SERVICE BULLETIN

M-1043

NEW CYLINDER BASE GASKETS AND CYLINDER STUDS

Figure 2. New Cylinder Studs.

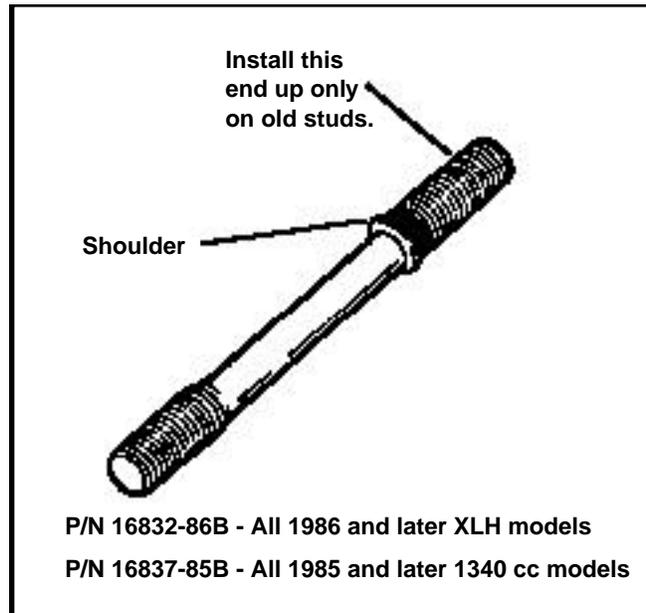
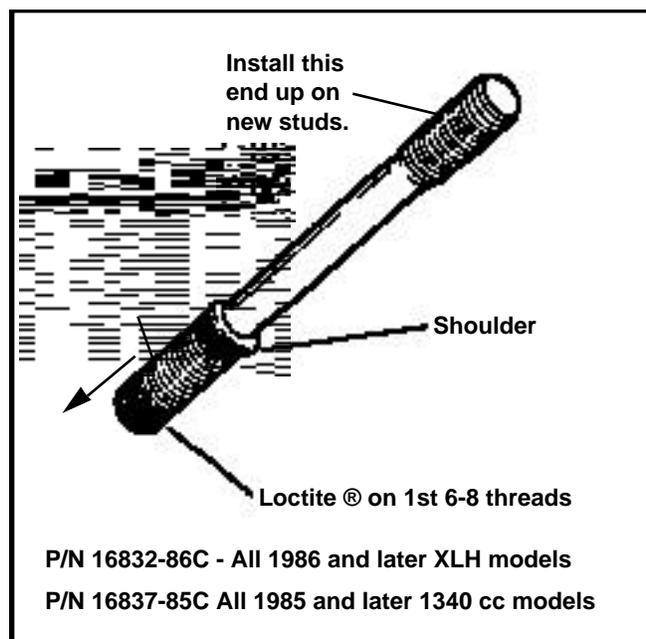
The new studs no longer provide an interference thread fit with the crankcase tapped holes. See Figures 1 and 2. Figure 1 shows the old cylinder stud, and Figure 2 shows the new stud.

See Figure 2. The new studs may be identified by the Loctite® applied to the first 6 - 8 threads on the shouldered end of the stud.

The new studs must be installed with the shouldered end down. Thread shouldered end into crankcase and tighten to 10 ft-lbs (13.6 Nm) torque. This torque should "bottom" the stud shoulder on the crankcase.

Old studs may be replaced with new studs as needed. If an old stud is bent or broken, replace it with a new stud. **It is not necessary to replace all old studs with new.**

If new studs are removed and reinstalled, apply Loctite® 271, red, to the crankcase - end threads of the stud.

Figure 3. New Gaskets Installed On Crankcase

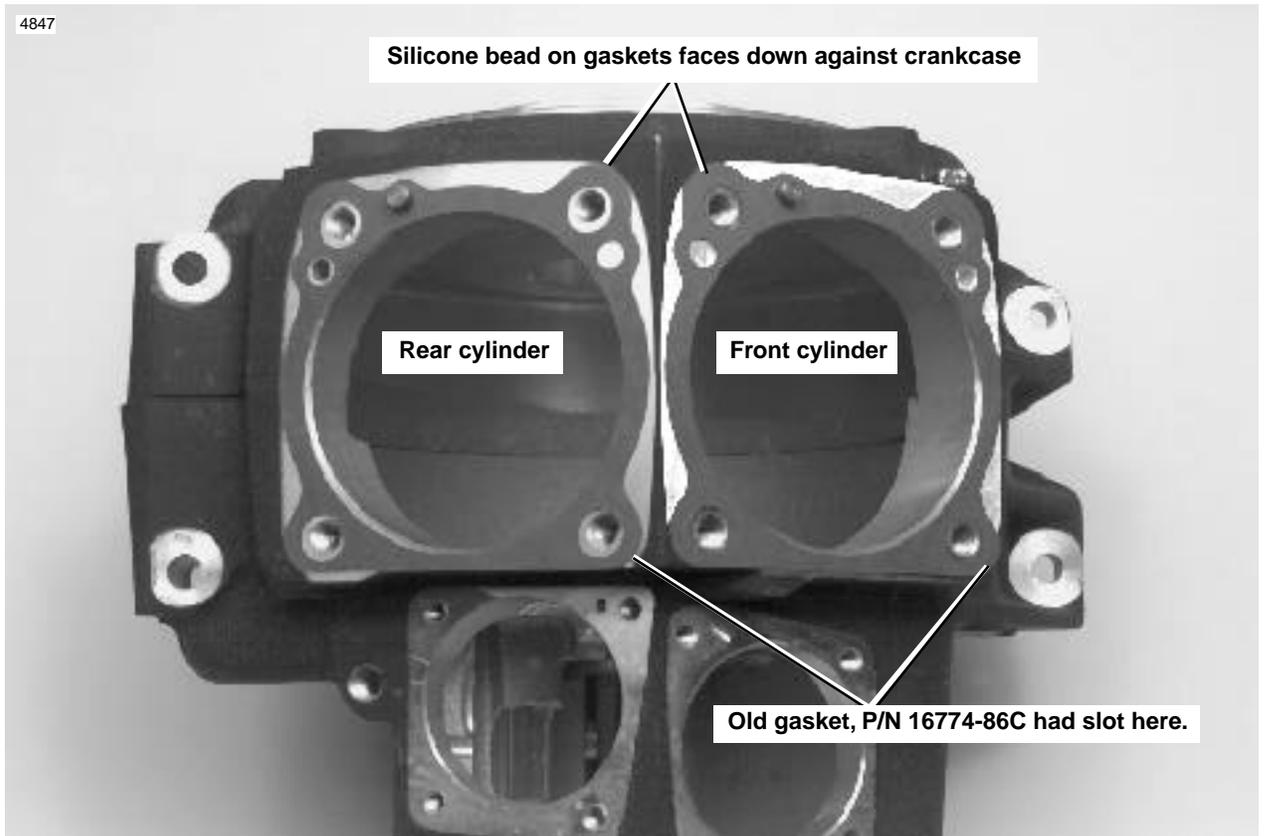
See Figure 3. The new cylinder base gaskets must be installed with the silicone bead facing the crankcase.

The new gaskets do not have the slot or cut-out at the hole as marked in Figure 3. Also, the new gaskets have a silicone bead on one side and are gray in color.

If your dealership has old cylinder base gaskets, Part No. 16774-86C, in stock, return them for credit. Order the new cylinder base gaskets, Part No. 16774-86D, to replenish your stock. See following "Credit Procedure" for details.
